**ADDENDUM No. 3**  
**Request for Competitive Sealed Proposals (CSP)**  
**19RFP060 Renovations at Reilly Elementary School**

**November 26, 2018**

ADDENDUM NO. 3  
TO THE  
DRAWINGS AND PROJECT MANUAL  
FOR  
**RENOVATIONS TO REILLY ELEMENTARY SCHOOL  
AUSTIN ISD  
AUSTIN, TEXAS**

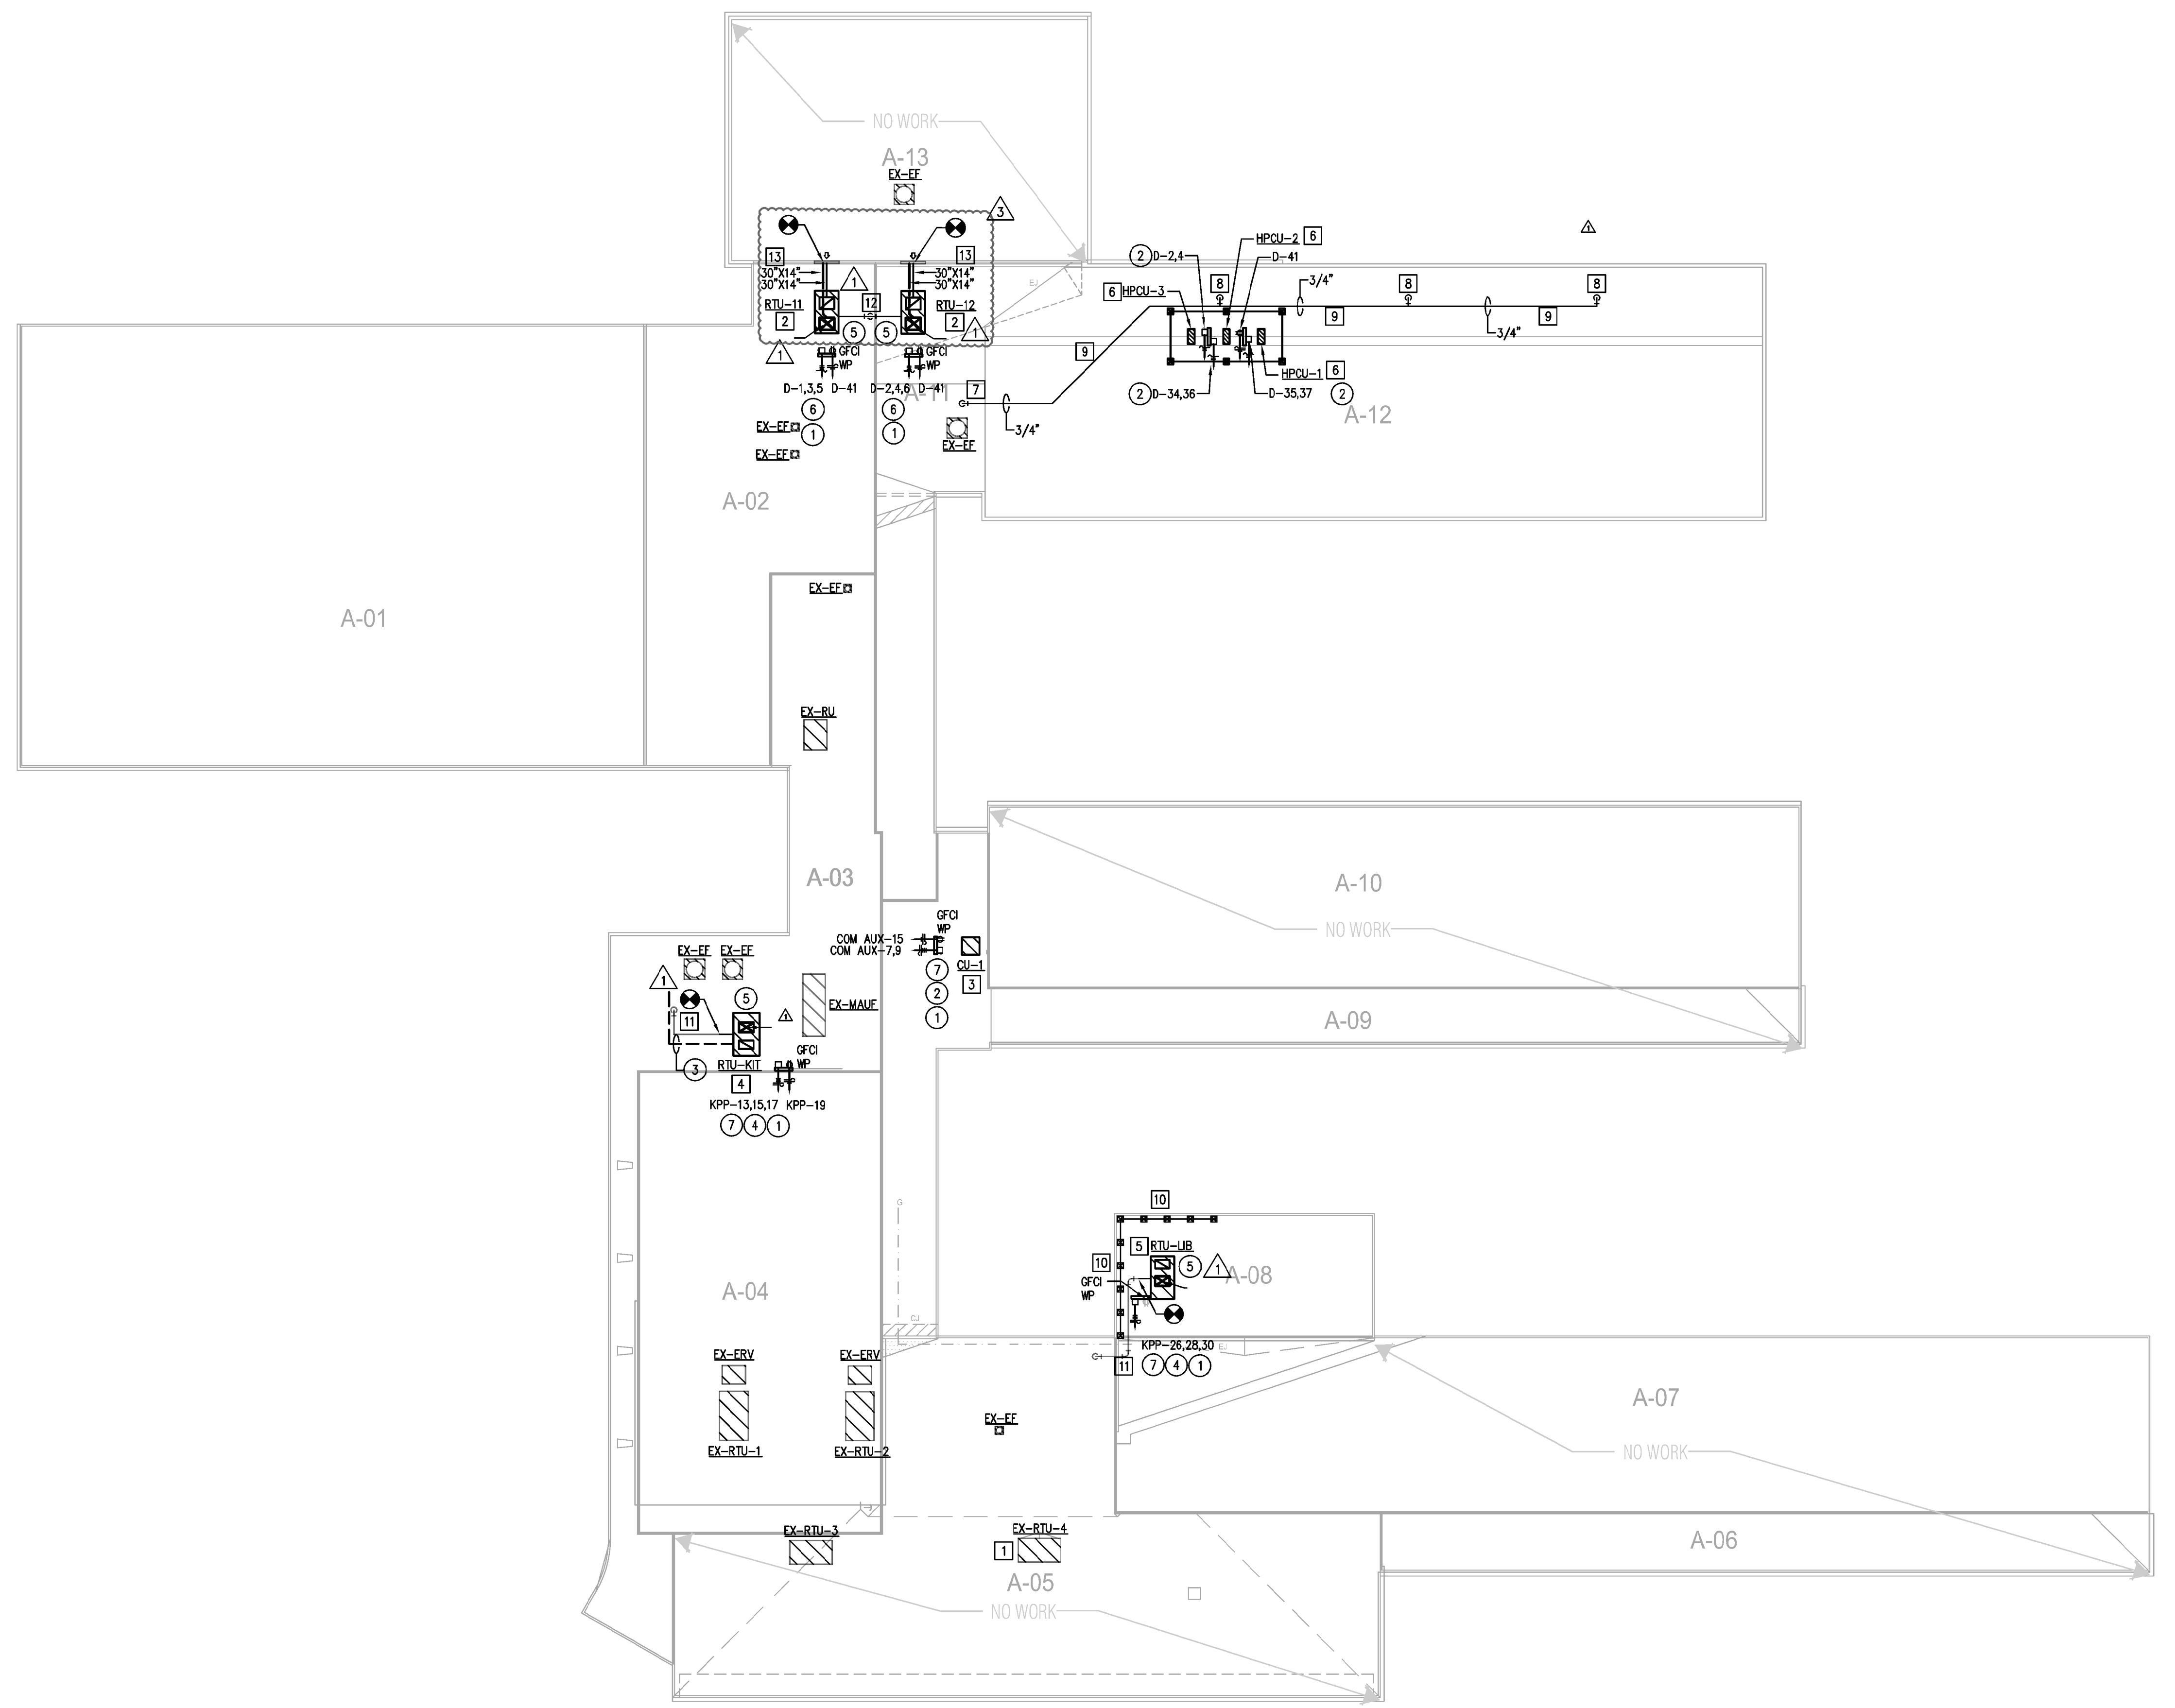
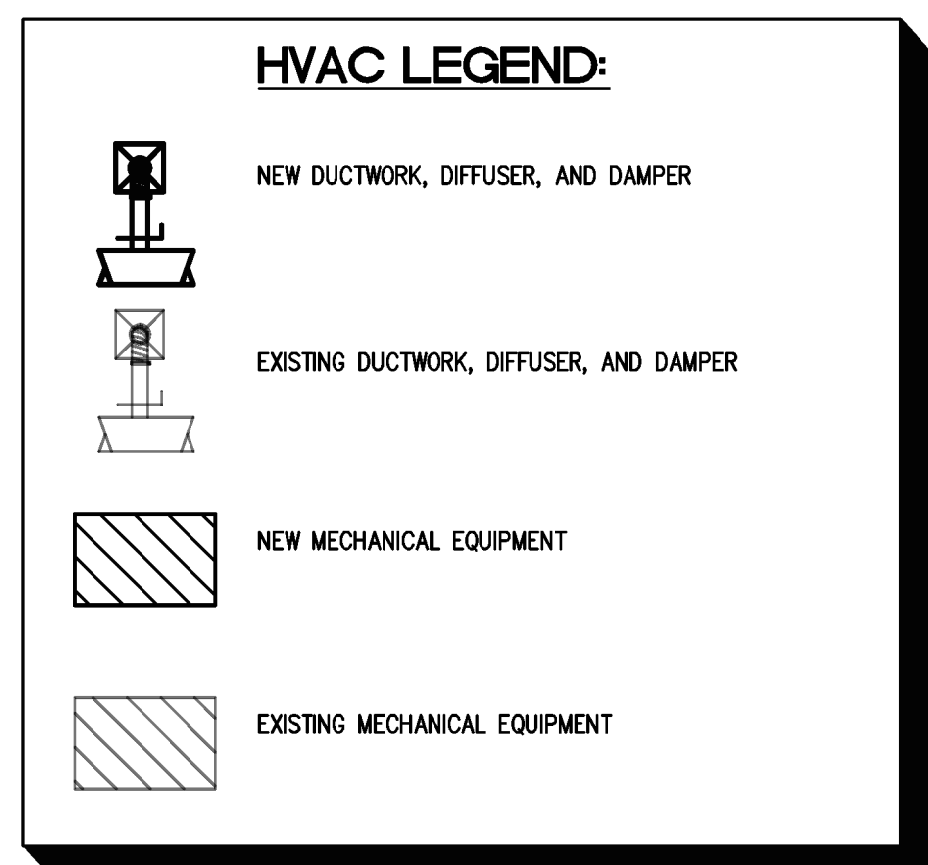
- 4. Question #4: Sheet MEP 2.03 Key note 2, states to install new unit further back from wall, but gives no other info on how far back. Can someone state a length, so we can all price the same?

5. Question #5: Sheet M6.01 detail 7 does not match detail A3.1 detail 3. What entity will be responsible for the condenser supports? Roofer.....GC...Mechanical?
  - a. A. Roofer will be responsible for condenser supports. Mechanical details sheet M6.01 has been updated to remove detail. Note on sheet MEP2.03 has been revised to refer contractor to sheet A3.1 for condenser roof rack detail.

### **3.7 SHEET MEP2.03 – MECHANICAL ROOF PLAN**

- A. Reference attached revised sheet. Added ductwork and associated notes for RTU-11 & 12.

- a. A. Length shall be around 3 feet, although this needs to be field verified as stated on updated plans. New RTU shall be installed with nearest side maintaining same gap between unit and gym wall as was before replacing existing WSHP. Duct length will also include routing within roof curb.

- 1 CONTRACTOR TO FIELD VERIFY EXACT ROUTING OF ROOFTOP UNIT CONDENSATE LINE. SEAL/REPAIR LEAKING PIPE AS REQUIRED.
- 2 PROVIDE NEW ROOF TOP UNITS TO SERVE GYM AT APPROXIMATE LOCATION SHOWN. UNIT SHALL BE INSTALLED IN SAME LOCATION AS PREVIOUSLY REPLACED UNIT, PROVIDING SAME DISTANCE BETWEEN UNIT AND GYM WALL AS WAS PRIOR TO REPLACEMENT. PROVIDE NEW ROOF FLASHINGS AND 4" HIGH ROOF CURB WITH DIMENSIONS EQUAL TO UNIT. UNITS SUPPLY & RETURN SHALL BE BOTTOM DISCHARGE AND BE ROUTED WITHIN ROOF CURB TO PENETRATE SIDE OF ROOF CURB. PROVIDE ALL DUCT TRANSITION PIECES AS REQUIRED TO RE-USE EXISTING PENETRATIONS INTO EXISTING GYM WALL AND CONNECT TO EXISTING SUPPLY/RETURN GRILLES. INSTALL UNIT PER MANUFACTURER'S INSTALLATION INSTRUCTIONS AND PROVIDE ALL REQUIRED CLEARANCES. PROVIDE DUCT SMOKE DETECTOR IN SUPPLY DUCT. REFER TO DETAIL #11 ON SHEET M6.01 FOR CURB DUCT ROUTING CLARIFICATION.

**1** NEW MECHANICAL PLAN  
 M2.02 1/16"=1'-0"

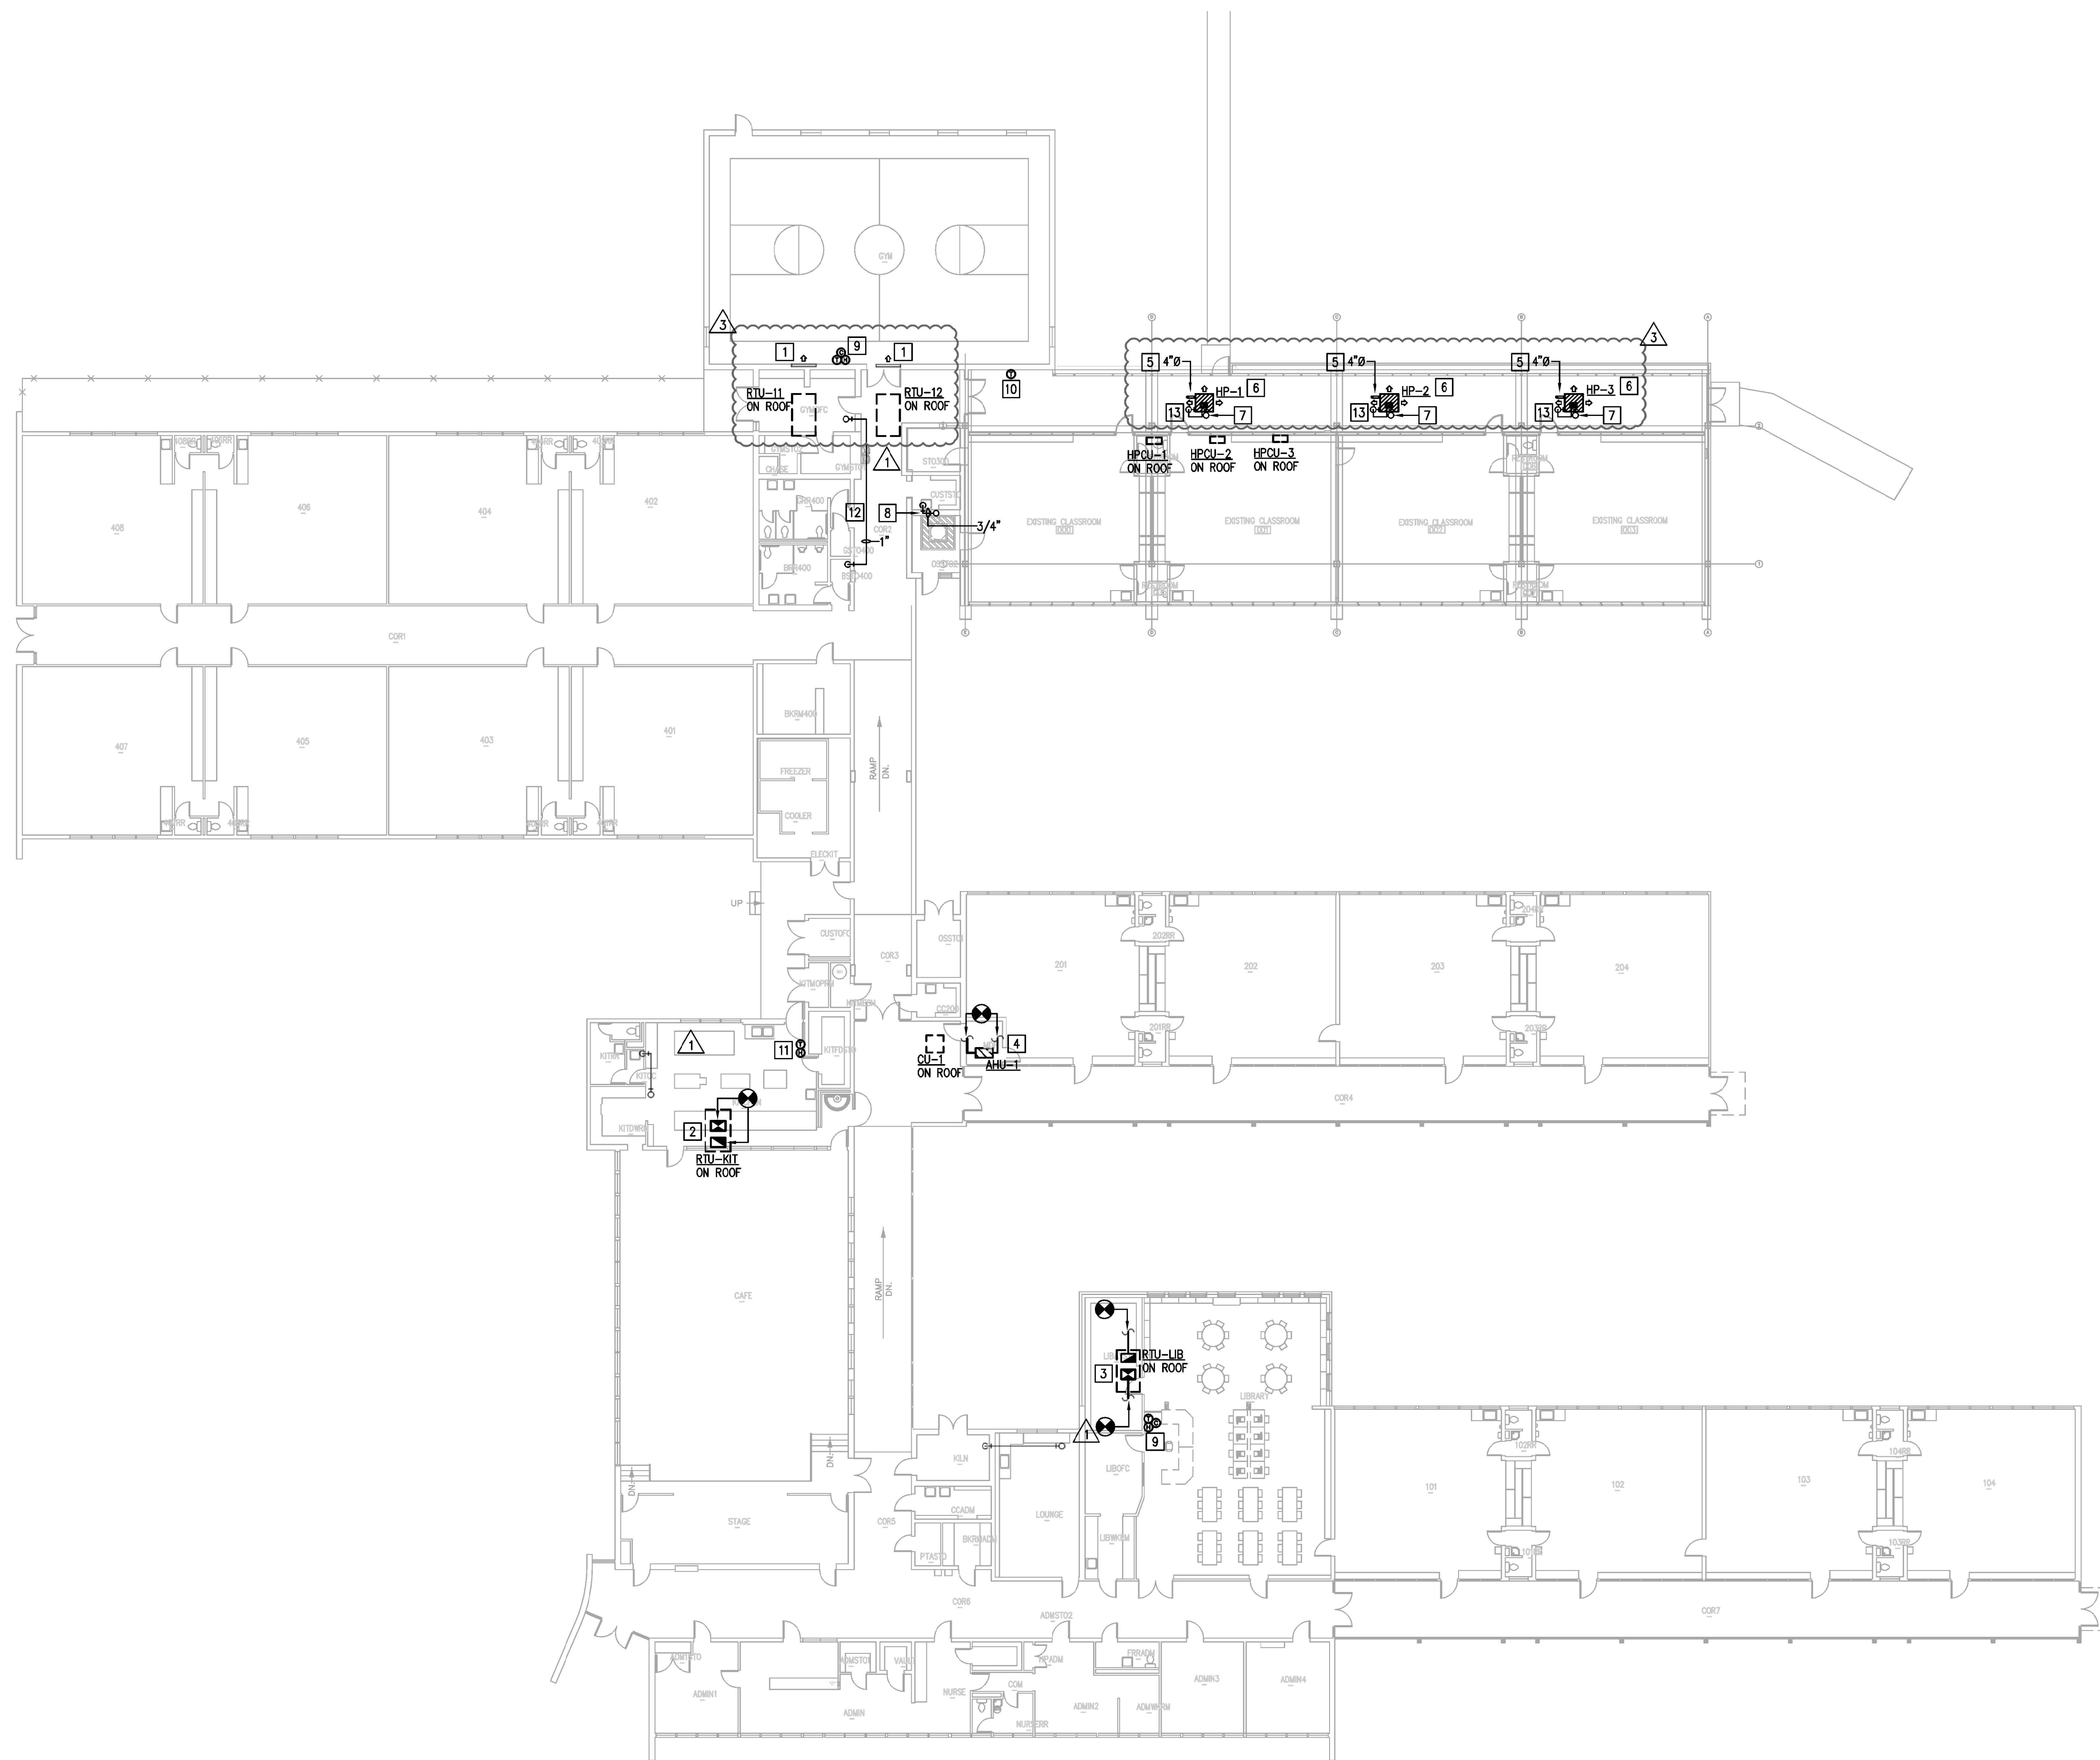
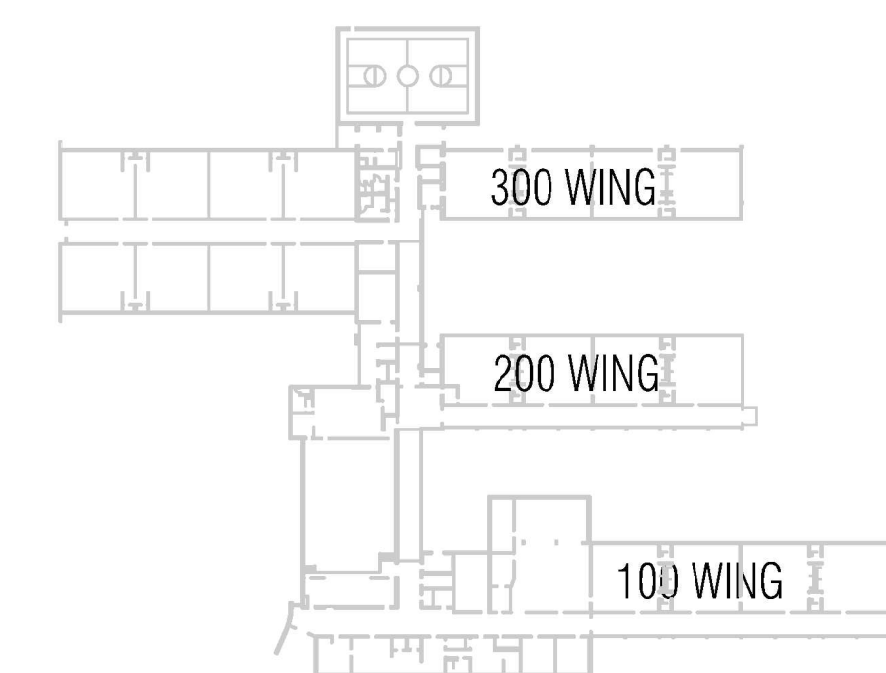
- D. CLARIFICATION RESPONSE TO RFI QUESTIONS
  - 1. Question #1: Sheet A2.01, Detail 2 shows the new A/C Cassette. At that elevation and the condensate on the roof being apx. 10" above the roof, will be a 36" rise for condensate to be pumped. The pumps that come with these units have very limited head. 20-22" is what I remember. Another pump option?

### **3.8 SHEET M2.02 – NEW MECHANICAL PLAN**

- A. Reference attached revised sheet.
  1. Revised supply duct for RTU-11 & 12 to be shown on roof plan.
  2. Revised cassettes to show with secondary condensate pump.

- a. A. Secondary pumps will be required to reach 36" rise. Provide secondary condensate pumps to be mounted near or on top of units (Model: Sauer mann, SI-30 or equal). Coordinate with manufacturer for installation recommendations. See sheets M5.01 for split system schedule notes & sheet M2.02 for mechanical floor plan.

- 13 PROVIDE SECONDARY CONDENSATE PUMP CAPABLE, MODEL SAUERMANN SI-30 OR EQUAL. FIELD VERIFY CLEARANCES FOR PUMP AND MOUNT ON TOP OF CASSETTE IF APPLICABLE. COORDINATE WITH MANUFACTURER FOR EXACT INSTALLATION RECOMMENDATIONS AND CLEARANCES REQUIRED. 3/4" CONDENSATE PIPE SHALL BE ROUTED FROM INTERNAL CONDENSATE PUMP WITHIN CEILING CASSETTE TO SECONDARY CONDENSATE PUMP. PROVIDE FITTINGS & PIPING AS REQUIRED TO MAKE PROPER CONNECTIONS.
